Draft Sirius Site SSP SEPP, 36-50 Cumberland Street, The Rocks

Submission to the Department of Planning and Environment
16 February 2018

City of Sydney

Figure 1.
Recommended revised maximum RLs protect views to the Sydney Opera House from the Sydney Harbour Bridge

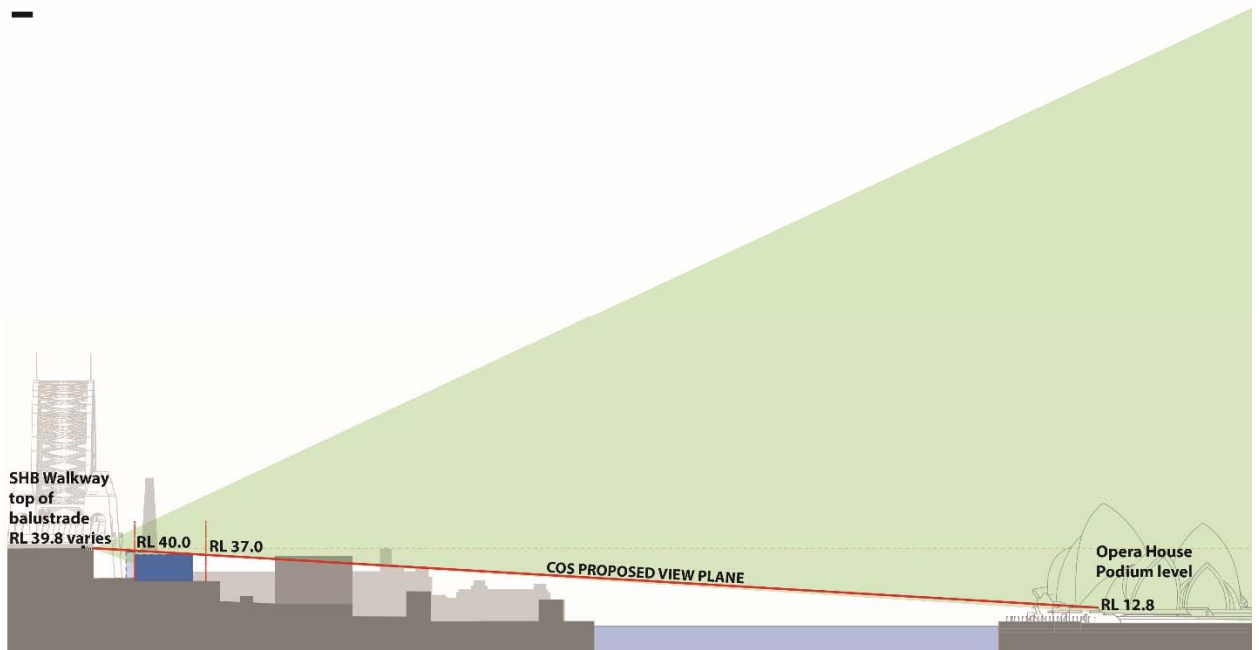
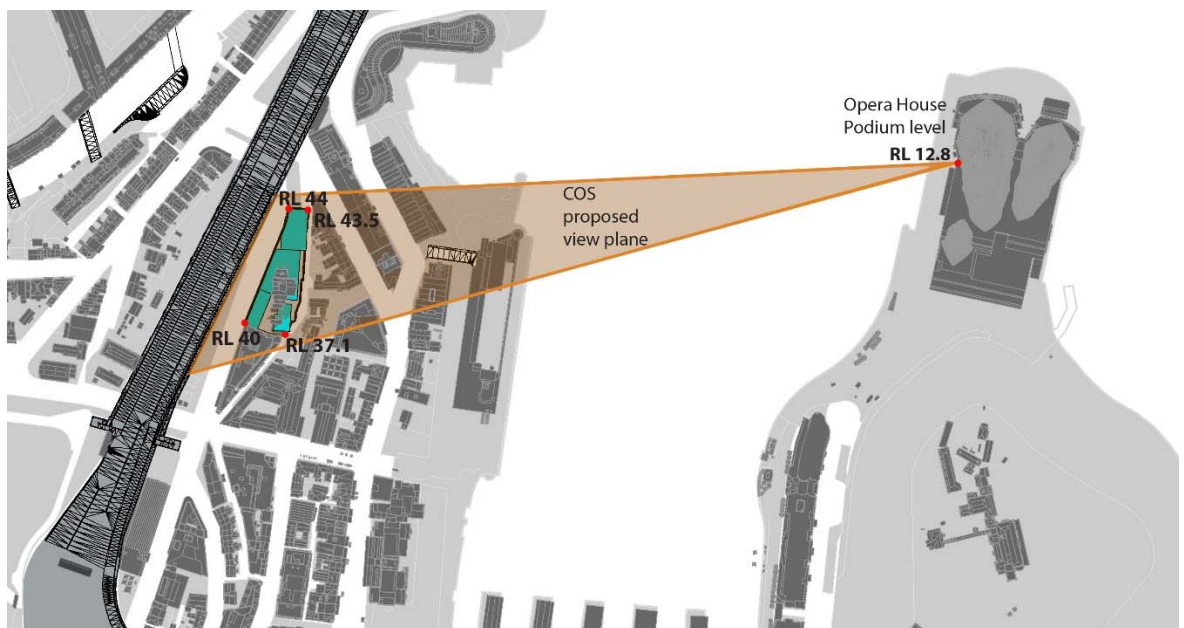
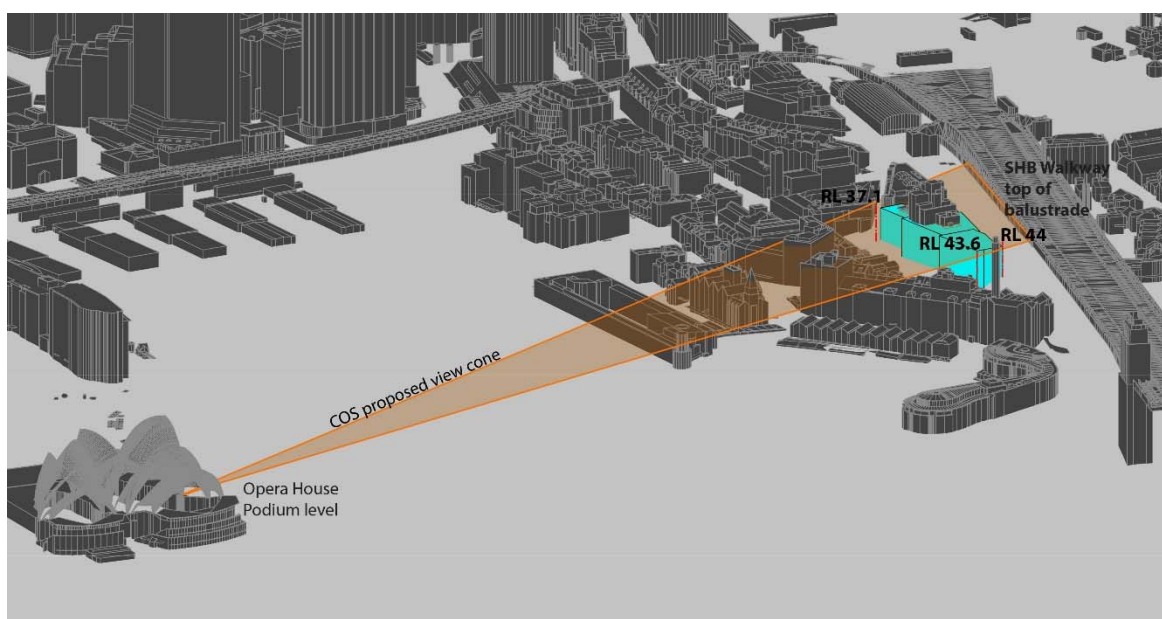
This approach will have significant unplanned impacts upon views to the Sydney Opera House by allowing lift overruns, parapets and all other services to impact views to the Sydney Opera House.

The City has reviewed the proposed maximum building heights and has developed revised maximum RLs to maintain views to the Opera House. These recommended maximum building heights include all built elements such as lift overruns, parapets, plant and all other services.

To facilitate this, the City proposes controls be introduced to maintain clear views to the sails of the Opera House from the pedestrian walkway on the eastern side of the Harbour Bridge that cannot be disrupted by any built elements. These controls are based on an inclined plane from the edge of the walkway balustrade to the top of the Opera House podium. This plane defines the maximum height for future development without affecting views to the Opera House. Indicative RLs are shown in red in Figures 1, 2 and 3. The specific coordinates of the proposed inclined plane are shown in Figure 4.

Introduce a new control to ensure no built elements project above an inclined plane from the edge of the walkway balustrade to the top of the Sydney Opera House podium.
